Response to the Comments of Anonymous Referee #2

We would like to thank anonymous Referee # 2 for his/her constructive comments. Our responses are:

Revised Figure 8. Cumulative baseflow estimated from ^{222}Rn activities, based on high k values, in flow conditions of $4894\text{--}18\,520\text{ mL day}^{-1}$ (A) and of $995\text{--}2606\text{ mL day}^{-1}$ (B). High cumulative baseflow usually occur in high flow conditions.

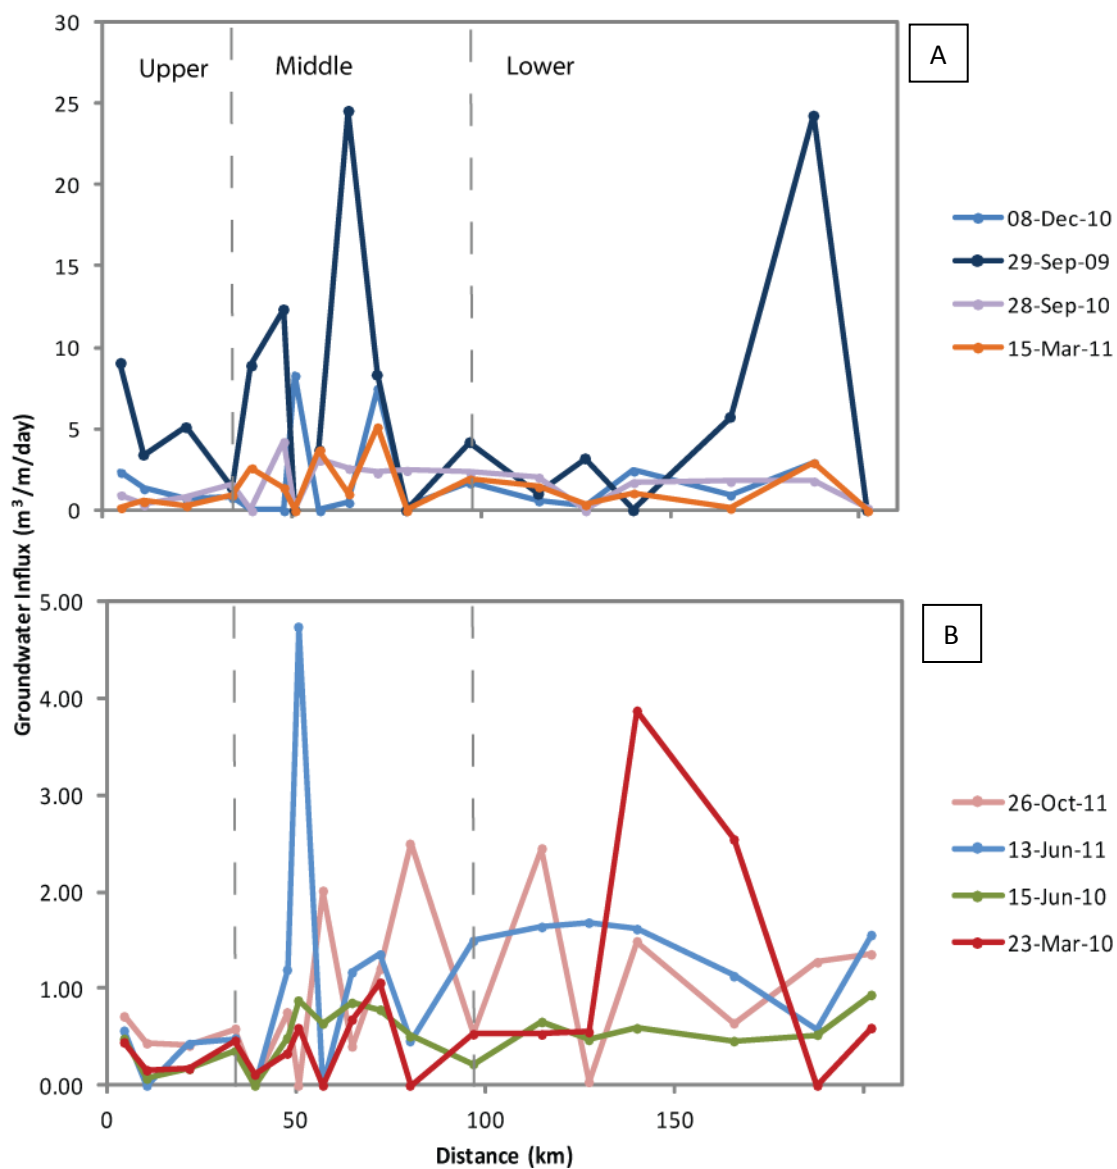
The excessive influxes of groundwater in the middle catchment shown in figure 8 are caused by calculation errors. Wrong values of river length were used to multiple the baseflow flux values obtained from the radon mass balance. The revised figure 8 shown below generally show a much more gradual increase in cumulative baseflow except for the locations where the basement highs occur, such as the distance between 65 and 72km. The strong saw-tooth pattern in groundwater fluxes shown in figure 7 may be caused by how the graphs present without showing data points of the sampling location. The revised figure 7 (with the data points) shows that groundwater influxes generally increase or decrease over several reaches. However, some particular sections of river do have a greater amount of baseflow due to their proximity to basement highs, such as distances between 65 and 72km, and between 166 and 188km. We also admit that the distance between sampling points in the lower catchment are much longer because of the difficult access to some of the flood plains.

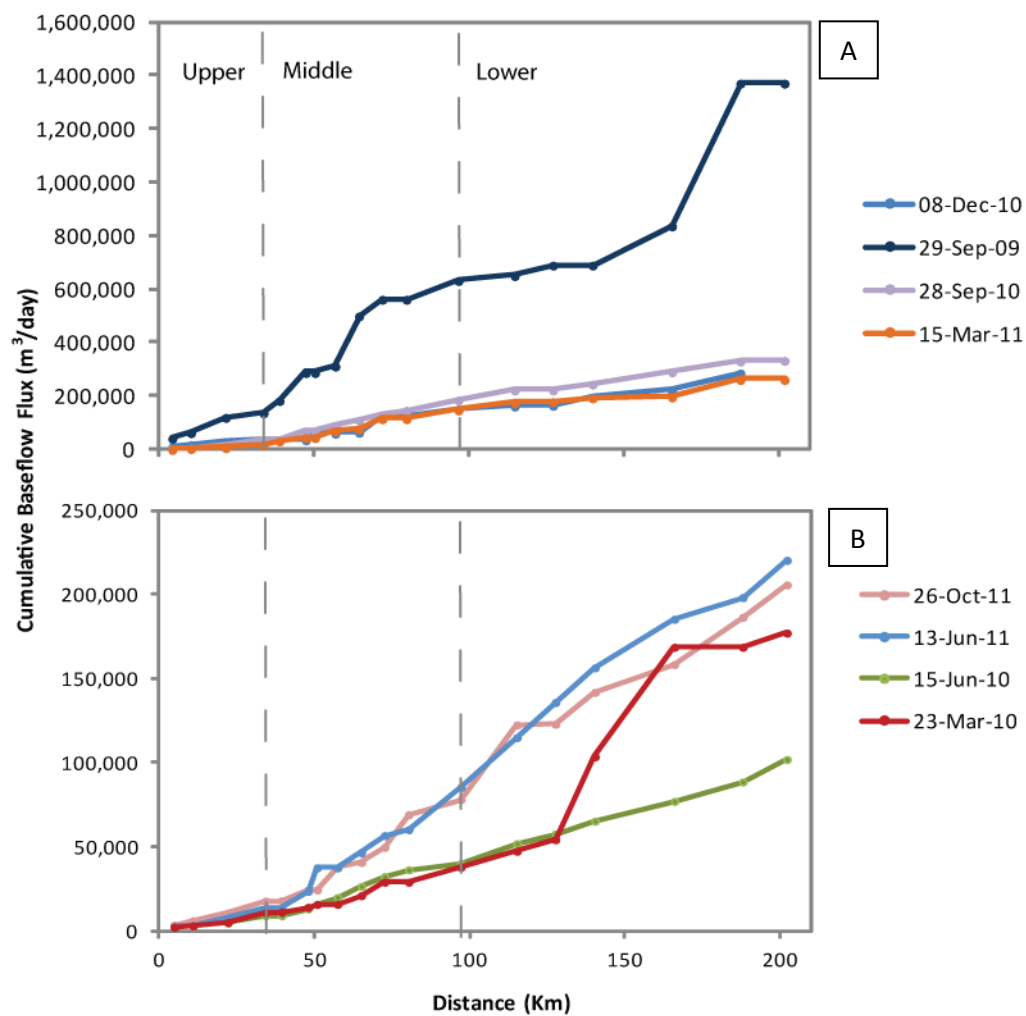
Figure 7 does show the highest groundwater inflow occurs in the middle catchment, rather than in the upper catchment. Two explanations account for this observation. 1) Basement highs that occur between 65 and 72km deflect groundwater flow, inducing upward head gradients and causing the high groundwater influxes; 2) Despite the widening of the valley, the river is moderately incised with steep banks. Moderately high gradient is still maintained between the watertable and the river, producing the observed high groundwater fluxes. Another important observation from figure 7 is that except for some of the large baseflow input, baseflow input in the lower catchment do not vary much between high flow (figure 7a) and low flow conditions (figure 7b). On the other hand, baseflow in the upper catchment (and to a degree, in the middle catchment) increases at high flows by more than 50%. This reinforces the finding that the hydrological loading of groundwater in the fast responsive aquifers in the upper and middle catchments following recharge induces a greater amount of baseflow in these catchments. These interpretations will be clarified in the final paper.

Revised Figure 7. Groundwater influxes calculated from ^{222}Rn activities, based on high k values, in flow conditions of $4894\text{--}18\,520\text{ mL day}^{-1}$ (A) and of $995\text{--}2606\text{ mL day}^{-1}$ (B). High baseflows occur in the upper catchment and often increase during high flow conditions. High baseflows also occur 65–72 km and 166–188 km.
